## CMB Meeting Minutes #171

REFERENCE Project No. M544.1, Contract No. 149 Task 1-8.02

SUBJECT: Configuration Management Board Meeting # 171 – Rev. No. 0

**Field Sketch No. FS 1252-080**  
**COR 018**

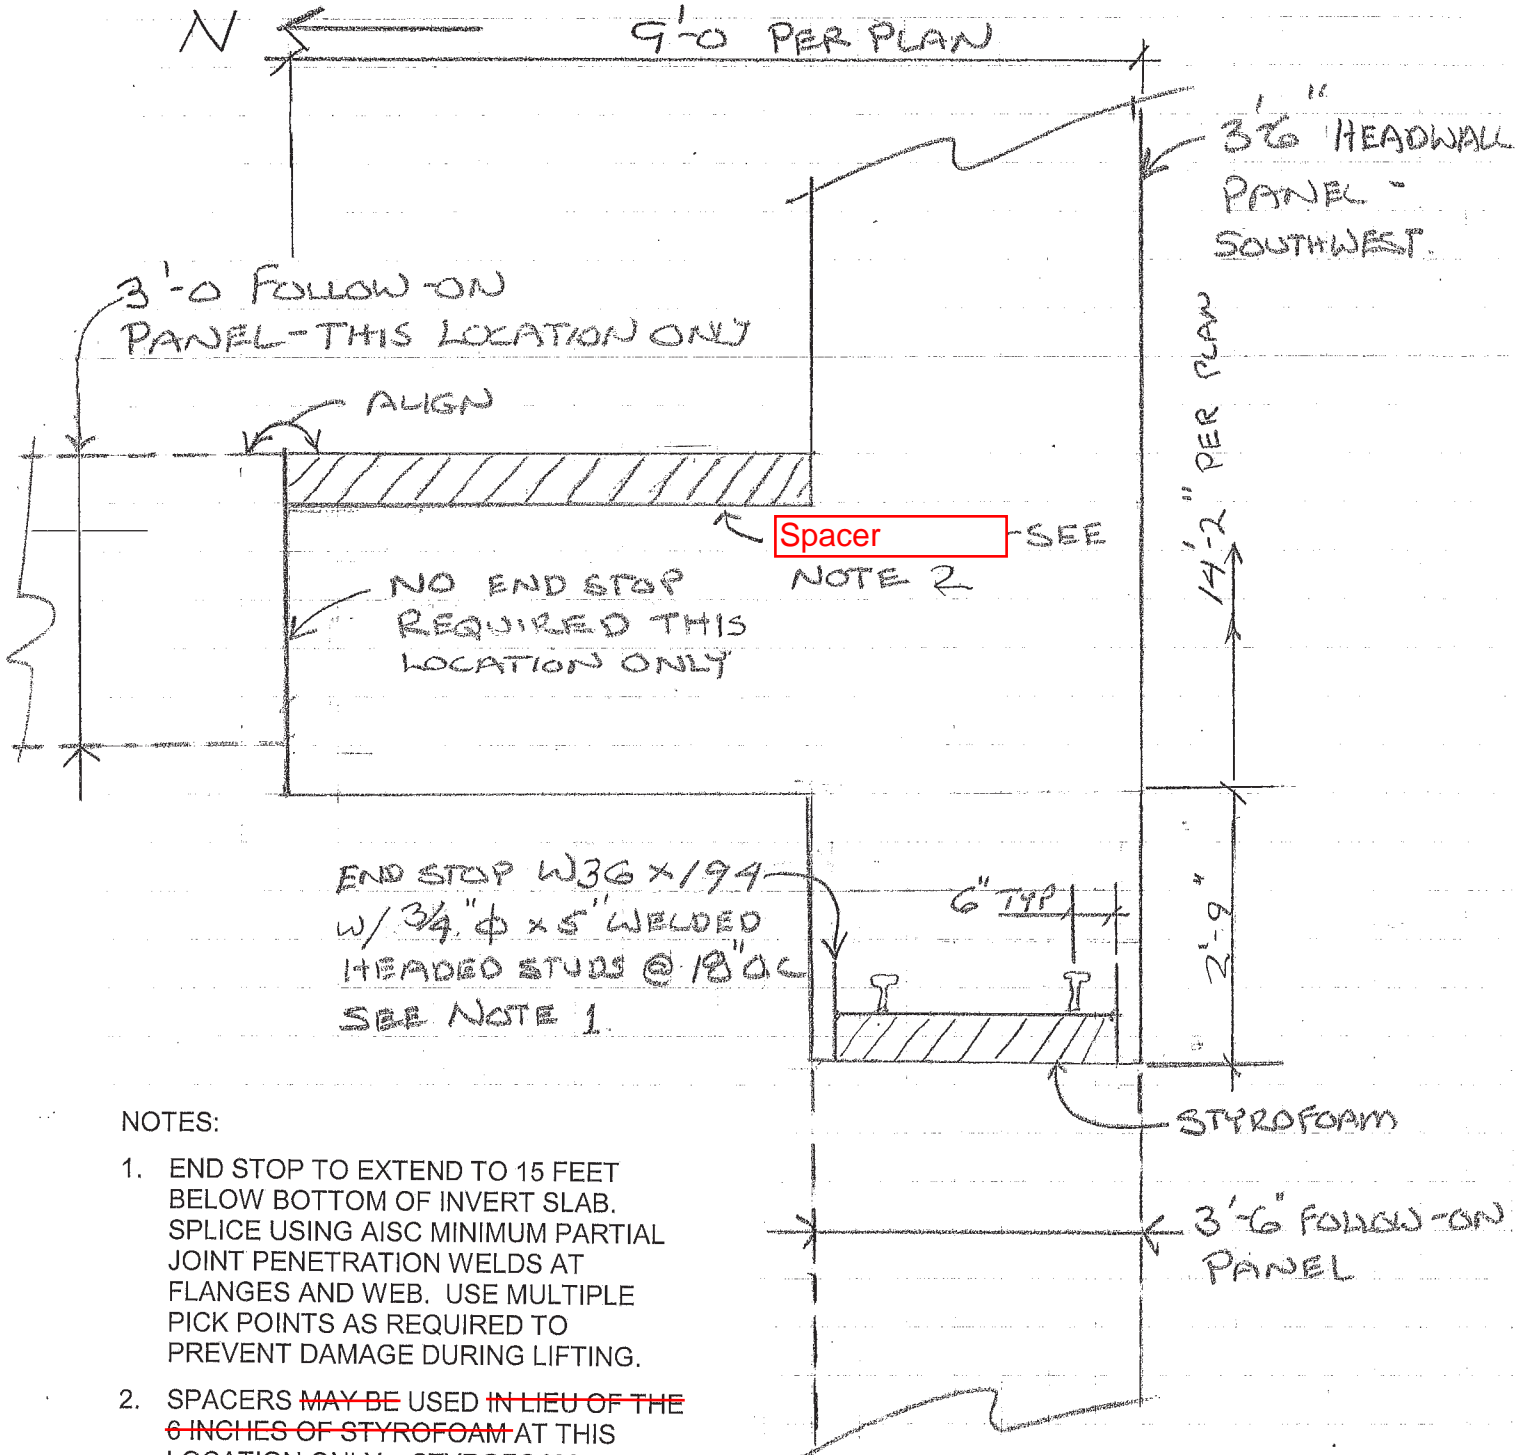
SFMTA required that the Contractor (BIHJV) leave end stops at the Moscone headwalls in place at the completion of Contract Number 1252 to provide positive groundwater cut-off during excavation of the Moscone station under Contract Number 1300. Contract 1252 drawings did not contain a design detail for the required end stops.

On September 17<sup>th</sup>, 2012, the City provided Clarification (Response to RFI 136.1) confirming that the MOS headwall SW panel layout/configuration is as shown on the Contract drawings and the City provided sketches showing alternate configurations at the MOS SW return walls to accommodate a wide flange beam "end stop" in lieu of the specified (PVC or rubber) waterstop.

1. END STOP TO EXTEND TO 15 FEET BELOW BOTTOM OF INVERT SLAB. SPLICE USING AISC MINIMUM PARTIAL JOINT PENETRATION WELDS AT FLANGES AND WEB. USE MULTIPLE PICK POINTS AS REQUIRED TO PREVENT DAMAGE DURING LIFTING.
2. SPACERS ~~MAY BE USED IN LIEU OF THE 6 INCHES OF STYROFOAM~~ AT THIS LOCATION ONLY. STYROFOAM BLOCKOUT IS REQUIRED AT END STOP WEB AS SHOWN.

4th St Yard  
Site Layout  
Phase 3

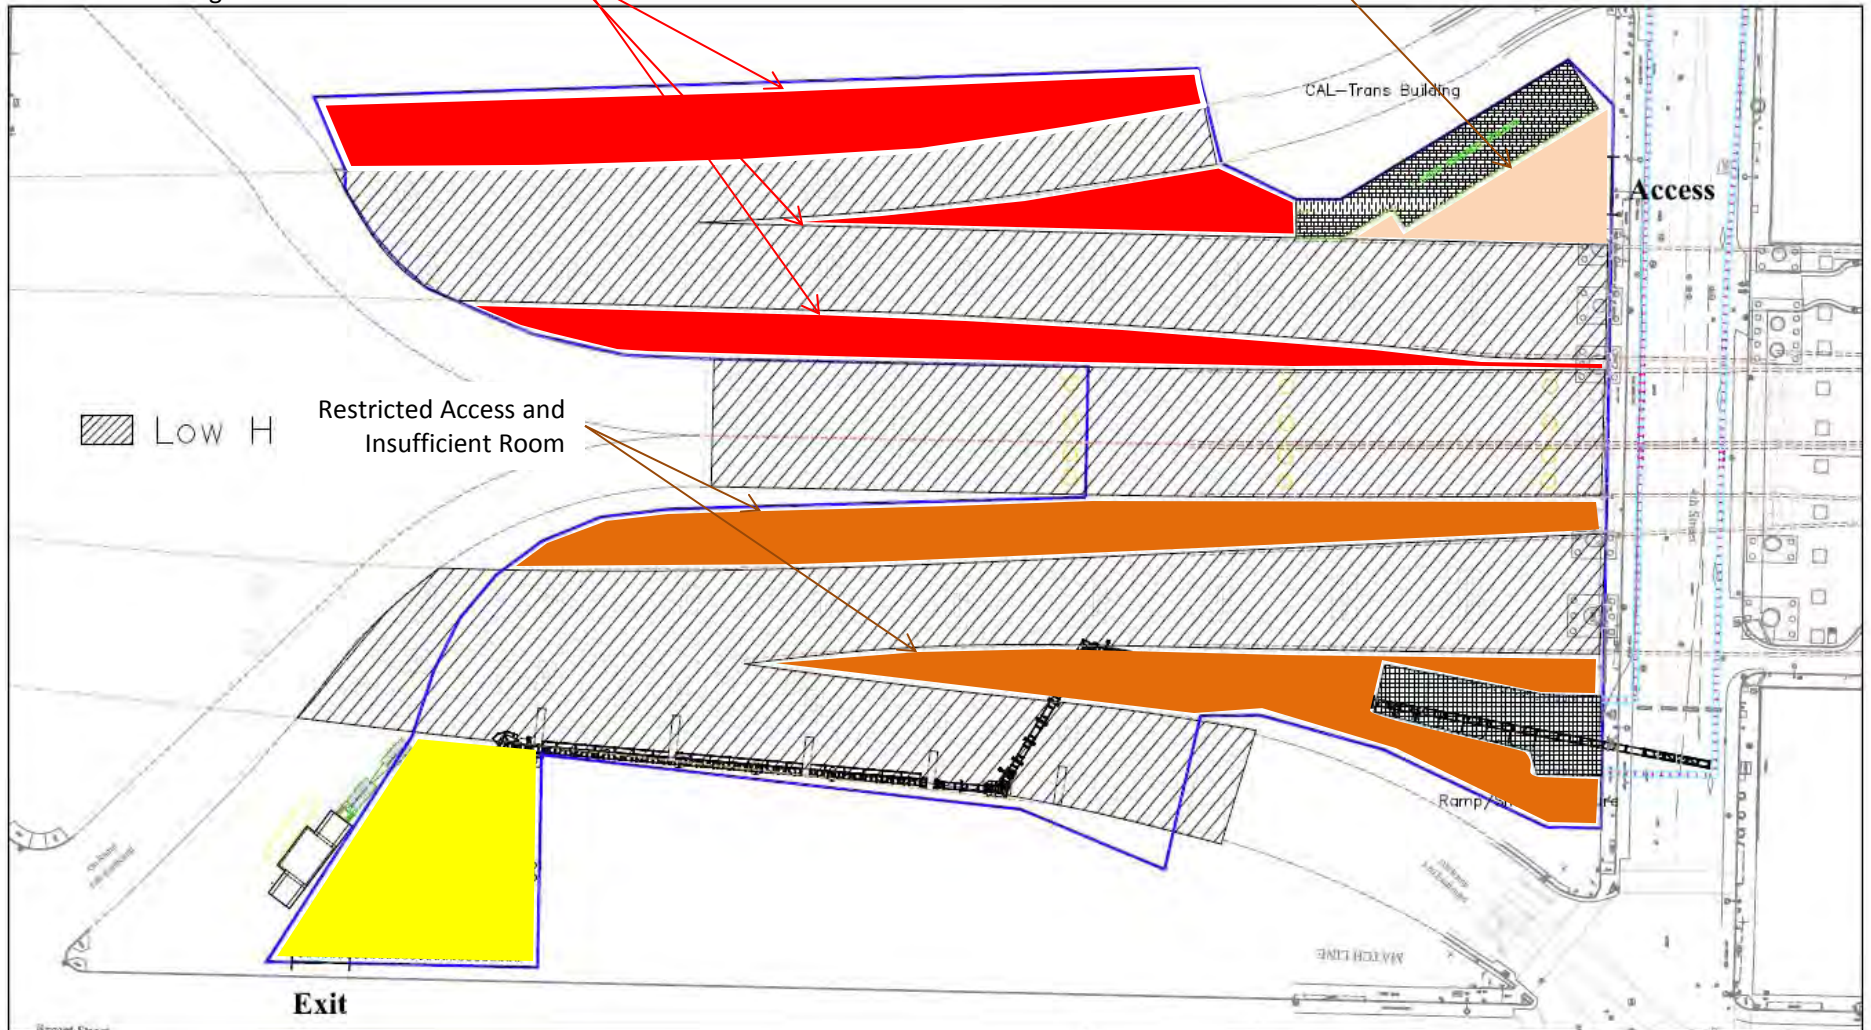
Per Caltrans Agreement,  
Designated as Maintenance Area

Insufficient Room

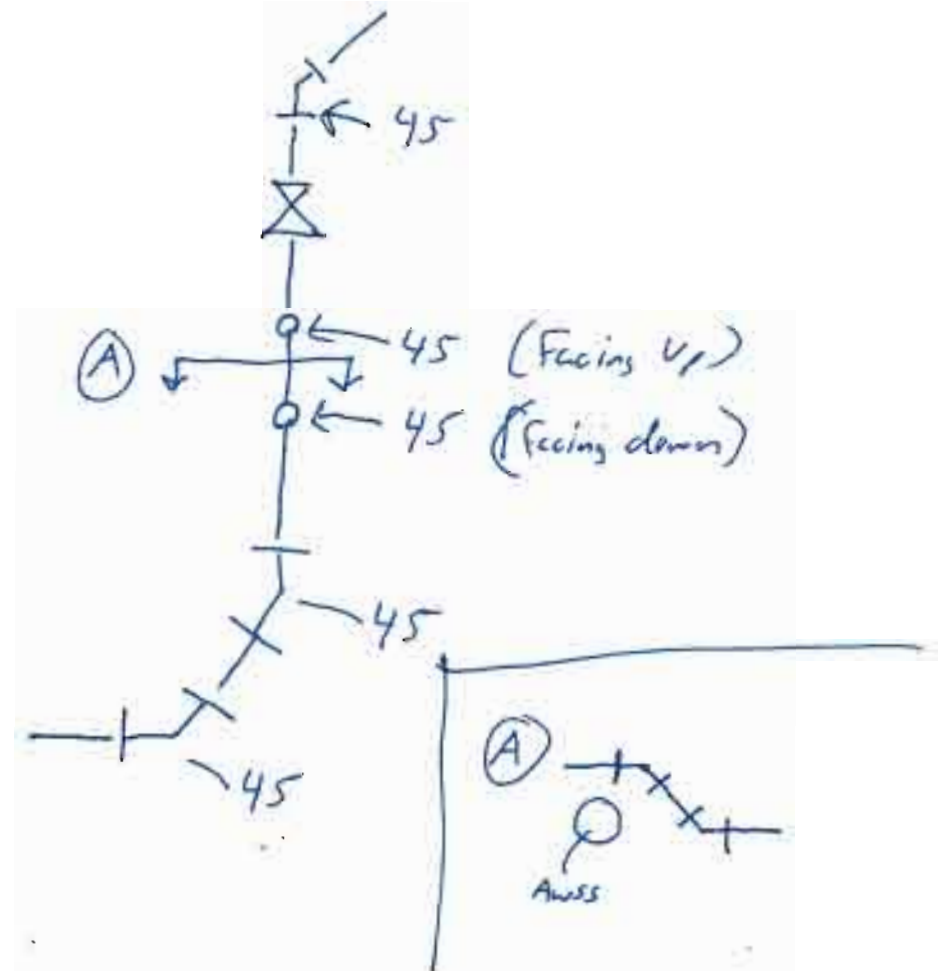
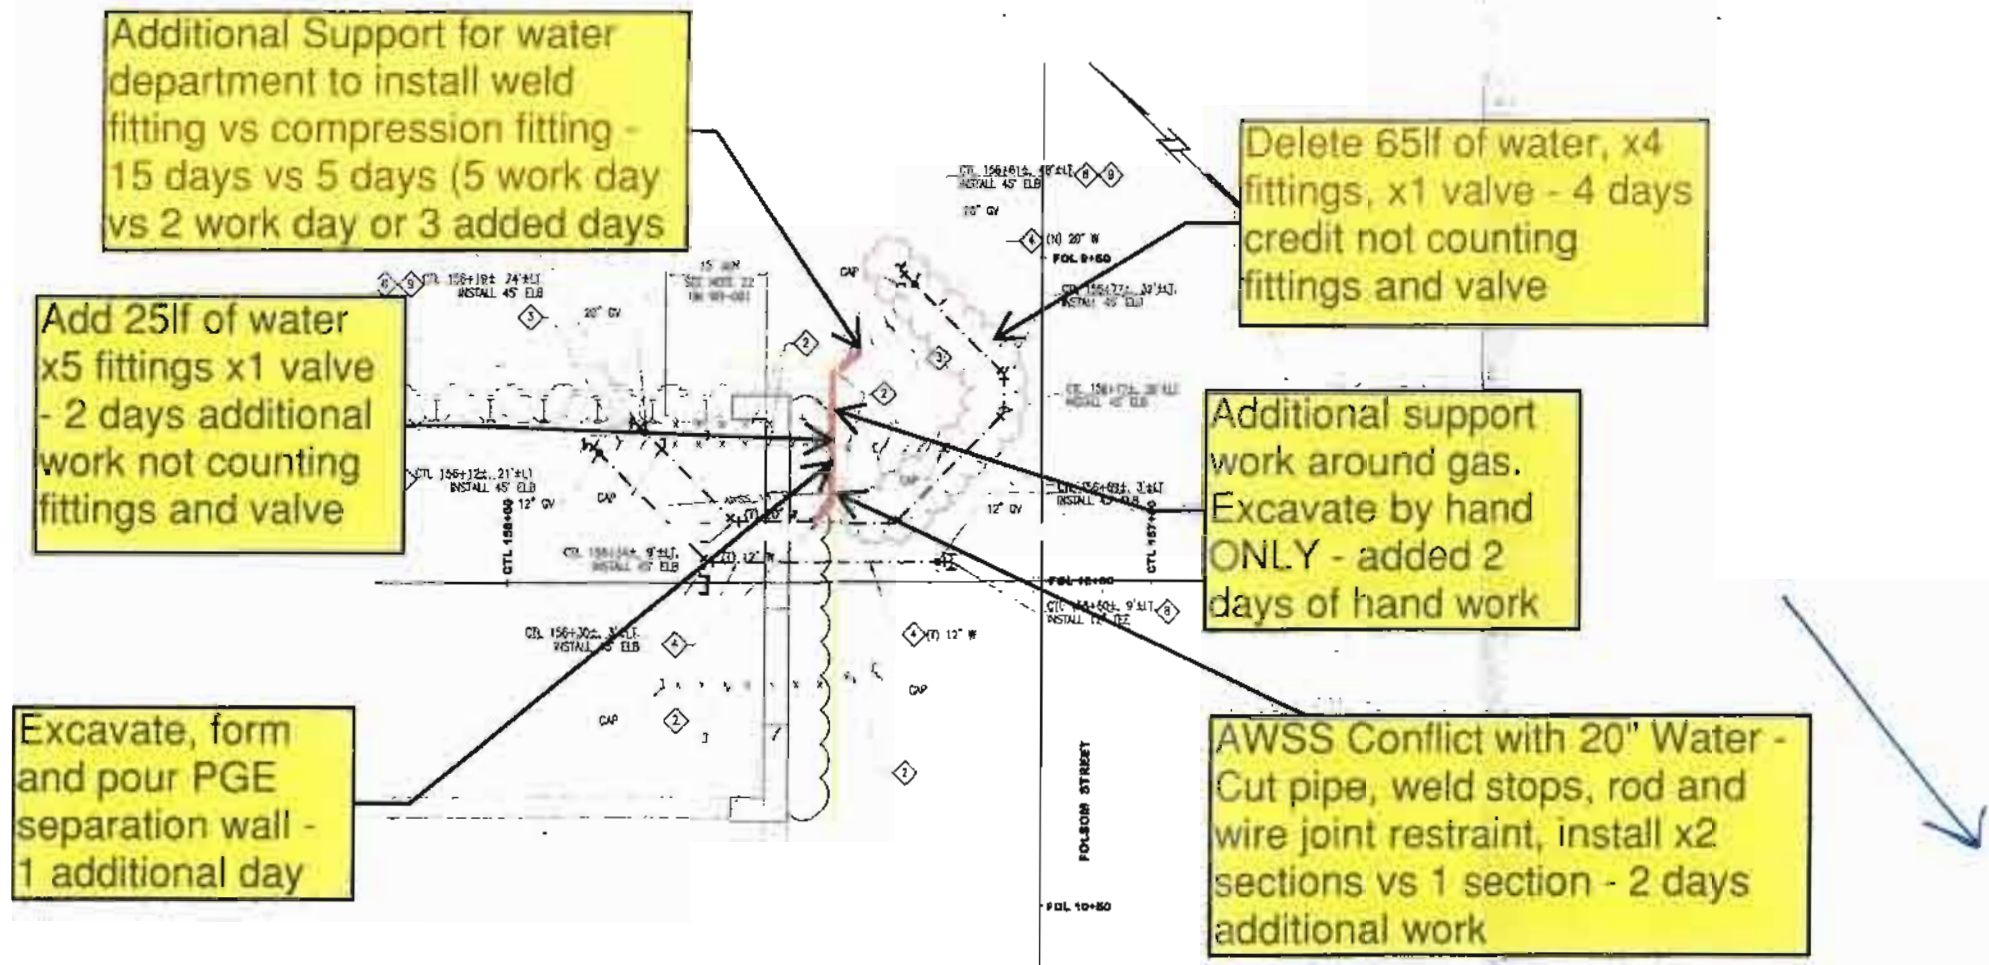
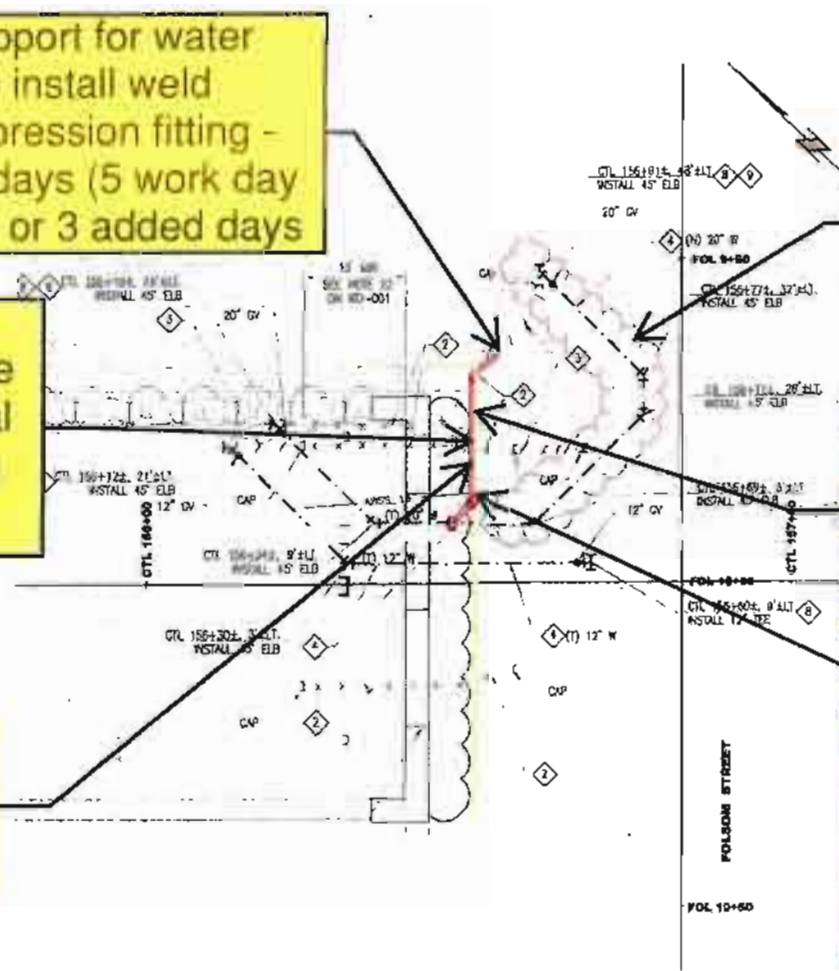
The Contractor submitted RFI No. 155 suggesting three (3) alternative alignments to reroute the waterline due to this conflict. The SFMTA allowed the Contractor to proceed with the installation alignment labeled 'option #1' in RFI No. 155. The modified alignment ran adjacent to an existing AT&T vault and required hand excavation of a hole underneath an existing gas main for the waterline to cross through. The revised alignment also reduced the overall length of waterline required to be installed by approximately 65 feet.

During installation of the waterline, per the revised alignment, the close proximity of existing utilities (see attached field sketch 1252-085) required that the Contractor utilize hand excavation methods and additional shoring. The Contractor's is claiming an additional two (2) days of work related to these additional excavation activities.

The Contractor claimed that the revised alignment required the use of a welded joint at the point of connection as opposed to the mechanical joint shown in the Contract drawings per the original alignment. The Contractor claimed the connection method lengthened the time required for SFWD's installation; therefore, additional SFWD support work was required to be performed by the Contractor. The Contractor's is claiming an additional three (3) days of work related to this additional SFWD support work.

The revised waterline alignment crossed an AWSS line at two (2) locations as opposed to the one (1) crossing shown in the original alignment. Additionally, the new alignment was in close proximity to a new AWSS trench excavated by the Contractor. As a result the Contractor was required to utilize hand excavation methods and additional shoring in order to protect the existing facilities. Additionally, the second crossing required the installation of an additional bell and stop collar. The Contractor's is claiming two (2) additional days of work related to these additional AWSS installation activities.

Additional Support for water department to install weld fitting vs compression fitting - 15 days vs 5 days (5 work day vs 2 work day or 3 added days)

Add 25lf of water x5 fittings x1 valve - 2 days additional work not counting fittings and valve

Delete 65lf of water, x4 fittings, x1 valve - 4 days credit not counting fittings and valve

Additional support work around gas. Excavate by hand ONLY - added 2 days of hand work
